STAFF REPORT July 18, 2017

AGENDA ITEM: (File No. SPAR-17002)

Consideration of a Site Plan and Architectural Review application to construct a 245-unit multi-family residential development. The 9.51 acre project site consists of two (2) lots located in the Twin Creeks Transit Oriented Development (TOD) Master Plan area within the Medium Mix Residential (MMR) zone. The site fronts North Haskell Street and is identified on the Jackson County Assessor's Map as 37S 2W 03C Tax Lot 138 and 37S 2W 03DC Tax Lot 3400. **Applicant:** Milo Smith, PCMI, Inc.; **Agent:** Scott Sinner, Scott Sinner Consulting, Inc.

Exhibit 3. Circulation Plan Detail

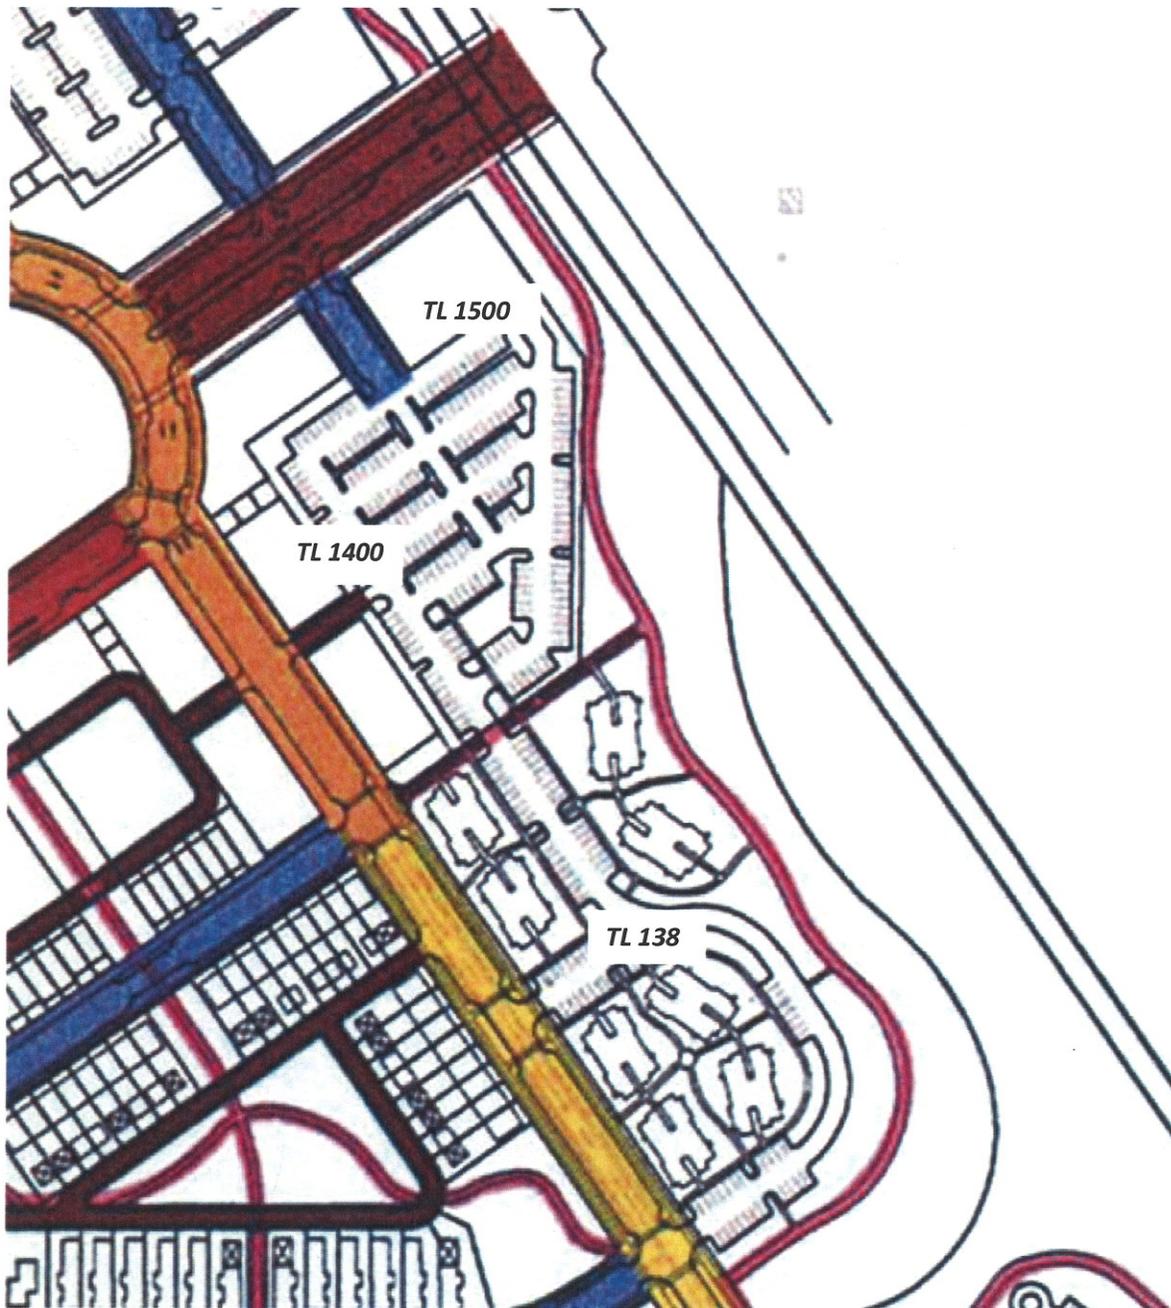
The purpose of this letter is to request a clarification of the Twin Creeks TOD Master Plan relative to Exhibit 3, Circulation Plan specifically for the following properties:

We would like shared access to be limited to use by emergency vehicles between these lots, which will be controlled by a fire access gate or other similar device. The basis of this request is that the Master Plan does not articulate a clear requirement for private shared access other than to illustrate a conceptual connection in Exhibit 3. If required to allow unlimited shared access, there are concerns that commercial traffic generated by a future land use on Tax Lot 1500 would be incompatible with and cause a safety hazard to future residents of the medium residential multifamily development on Tax Lot 138. By limiting access to emergency vehicles only, concerns about resident safety will be addressed.

1. Prior to building permit issuance for any structure in any Phase, the Applicant shall provide a copy of a signed and recorded reciprocal access easement with the adjoining parcel to the North (37S 2W 03CA Tax Lot 1500 and 37S 2W 03CA Tax Lot 1400) (“Lots”) as necessary to allow shared access between the Lots for emergency purposes only.

Figure 2 – Master Plan Exhibit 3

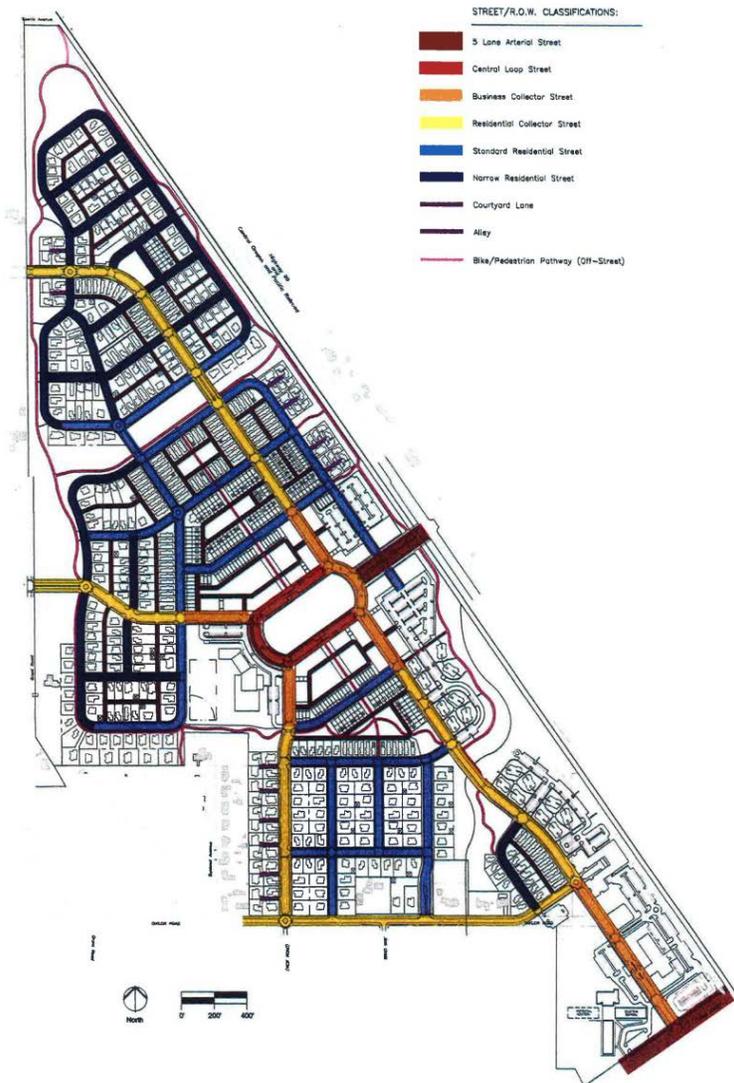
- h. Pedestrian Accessway.** Written testimony in Exhibit 4, referenced the proposal's compliance with the Master Plan Exhibit 3, Circulation and CPMC 17.67.040(A)(9) relative to off-street pedestrian accessways. Specifically, there is a 65-ft segment of the proposed minor pedestrian accessway that does not comply with the standard as illustrated on the site plan, but which can comply if relocated. The letter asked if owner approval has been obtained to relocate the path.

Finding: Master Plan Exhibit 3, Circulation: There is "an opportunity to relocate (a) portion of" a 65 foot section of the Off-Street Pedestrian Accessway. Regarding **Finding 17.67.040 (A) (9)**, "the Applicant shall coordinate with Twin Creeks Development Co. to locate a portion of the path...." Has that been done?

Comment: As conditioned, the Applicant is required to provide written authorization from the open space tract owner (i.e. Twin Creeks Development Co., LLC) to relocate the subject section of the pedestrian accessway. This requirement must be met prior to building permit issuance. No evidence was submitted during the open record period demonstrating this requirement has been satisfied. If not satisfied, building permits will not be issued. No additional conditions are recommended.

- 2) Off-Street Pedestrian Accessways. An off-street pedestrian accessway is identified on Exhibit 3 (Figure 2) providing connectivity between North Haskell Street and Twin Creeks Crossing along the Griffin Creek open space corridor for public purposes. As illustrated on the Applicant's Site Plan for Phase 1 (Figure 5), a Minor Pedestrian Accessway is proposed along the project site perimeter from North Haskell Street to the northeast property boundary. The proposed design complies with the Minor Pedestrian Off-Street Accessway Cross Section identified as Exhibit 12 in the Master Plan with the exception of a 65-ft section at the north east property corner. Since the Master Plan doesn't indicate whether the pedestrian accessway is to be located on the project site or the adjacent open space lot, there is an opportunity to relocate this portion of the pathway on the adjoining open space lot and provide the required cross section. As conditioned, the Applicant is required to provide written authorization and a revised site plan demonstrating compliance with the Minor Pedestrian Accessway standard per the Master Plan prior to building permit issuance (Condition No. 4). As conditioned, the Project can comply with Master Plan Exhibits 3 and 12.
